Cromer Road, Barnet Local Safety Scheme Stage 1 Road Safety Audit

June 2019

Document Reference: 33-19

Urban Vision Partnership Limited is instructed by Regional Enterprise Limited on behalf of the London Borough of Barnet to carry out a Stage 1 Road Safety Audit on the proposed 20mph and traffic calming options on Cromer Road, Shaftesbury Road and Bulwer Road in Barnet, London.

1 – Problem 2.2

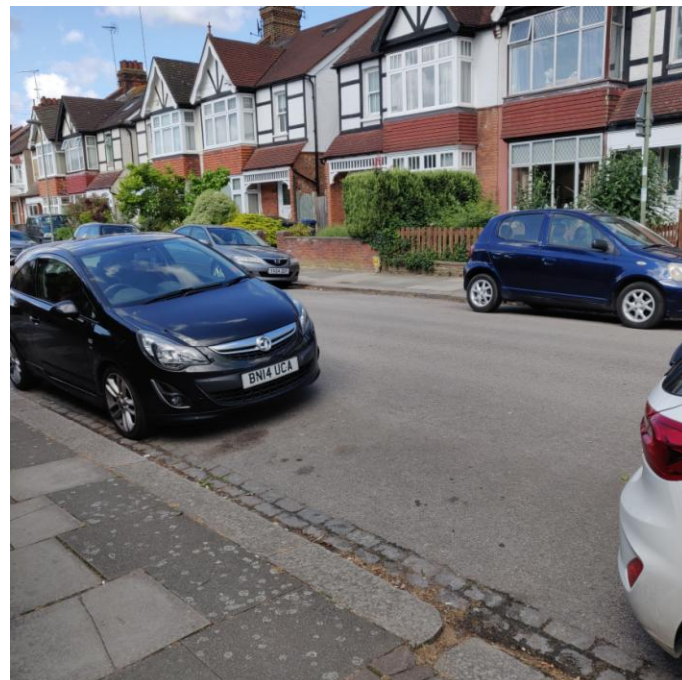
Location: Shaftesbury Avenue (See Photo 1)

Summary: *Risk of loss of control type collisions*

It is proposed to locate a set of speed cushions on Shaftesbury Avenue outside property no. 8. During the site visit, the audit team noted an existing service cover in the carriageway at this location. There is concern that the co-location of the service cover and proposed speed cushion may cause difficulties during construction and become hazardous to motorists where there is a risk of loss of control type collisions.

Recommendation:

Relocate the speed cushions away from the service cover on Shaftesbury Avenue.

Appendix B Reference Plan Option 1

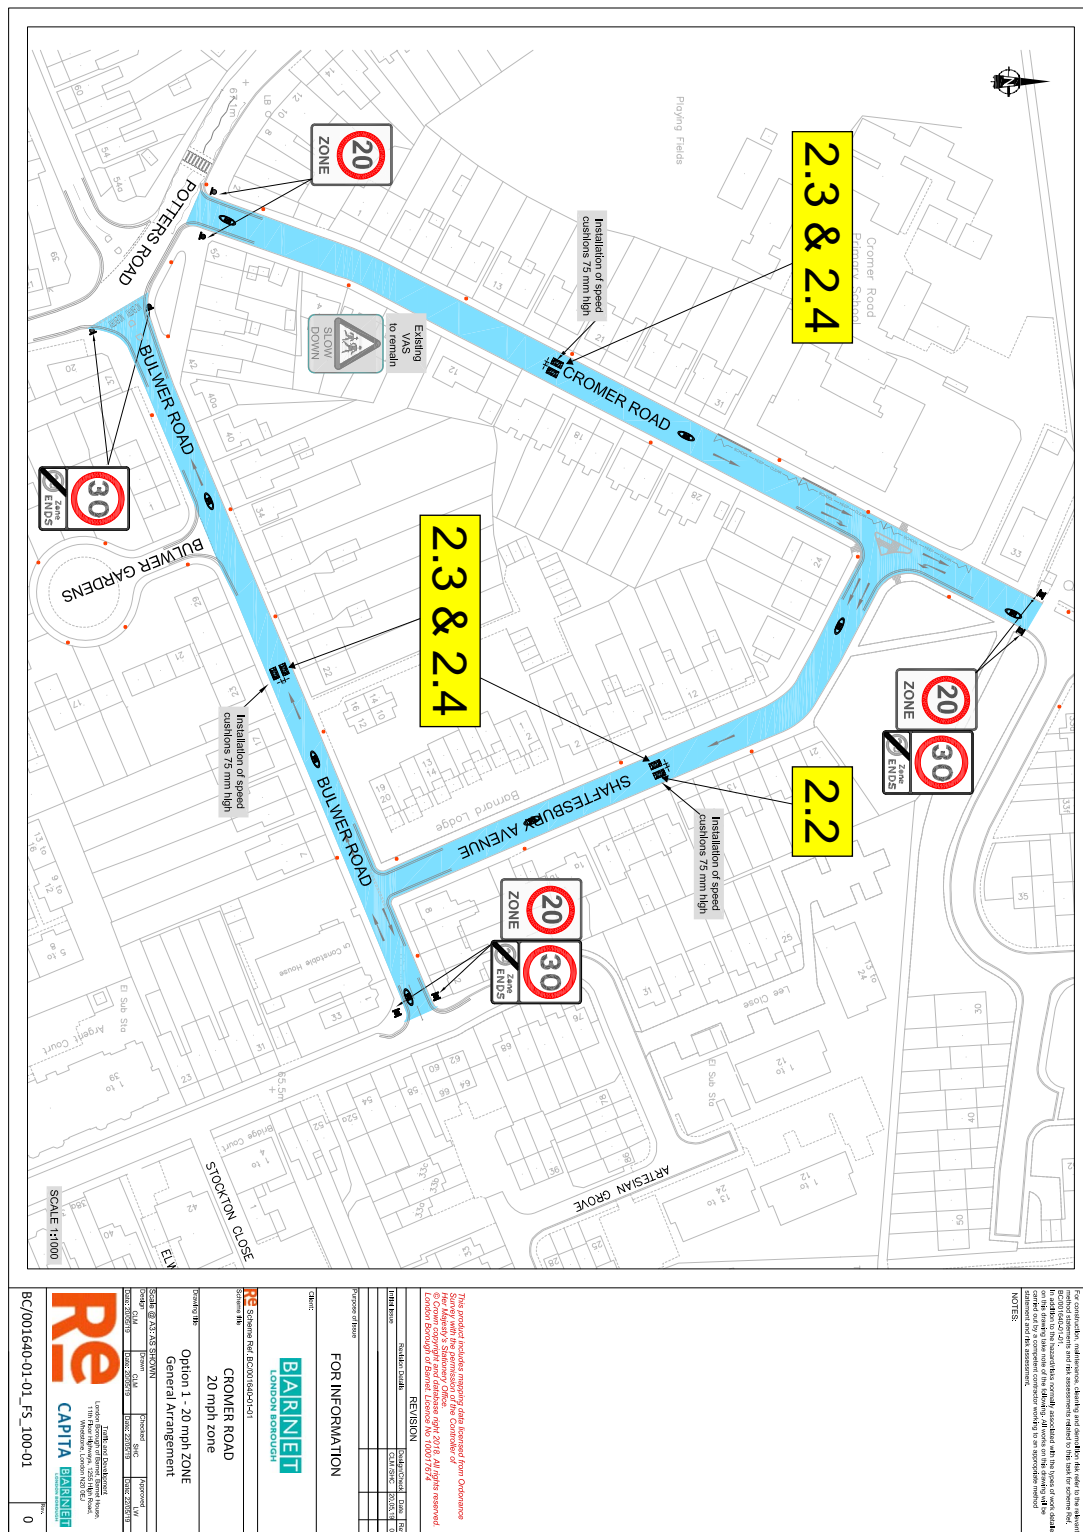
Location: Throughout (See Photo 2, 3 and 4)

Summary: *Risk of personal injury to passengers.*

It was noted during the site visit that vehicles park along both sides of the one-way roads which forces moving traffic to travel down the centre of the carriageway. The audit team have concerns that motorists, particularly those in buses and emergency vehicles, will be unable to straddle the cushions as parked vehicles will force them to override the 'shoulders' of each cushion resulting in maximum discomfort to passengers, potentially causing injury. Repetitive, heavy loading on the shoulders of the cushions will also cause damage over time, reducing their effectiveness in maintaining low vehicle speeds.

Location: Throughout (See Photo 2, 3 and 4)

Summary: *Risk of speed related collisions in future.*

Further to 2.3 above, when there are no vehicles parked adjacent to the cushions, there is potential for motorists to deviate from the centre of the carriageway towards the kerb to fully straddle the cushions where there is a risk of side-swipe type collisions with adjacent cyclists.

Recommendation:

Ensure motorists are able to straddle the cushions without being forced to override the 'shoulders' due to adjacent parking.

Recommendation:

Ensure motorists are able to straddle the cushions without any sudden deviation in their path.
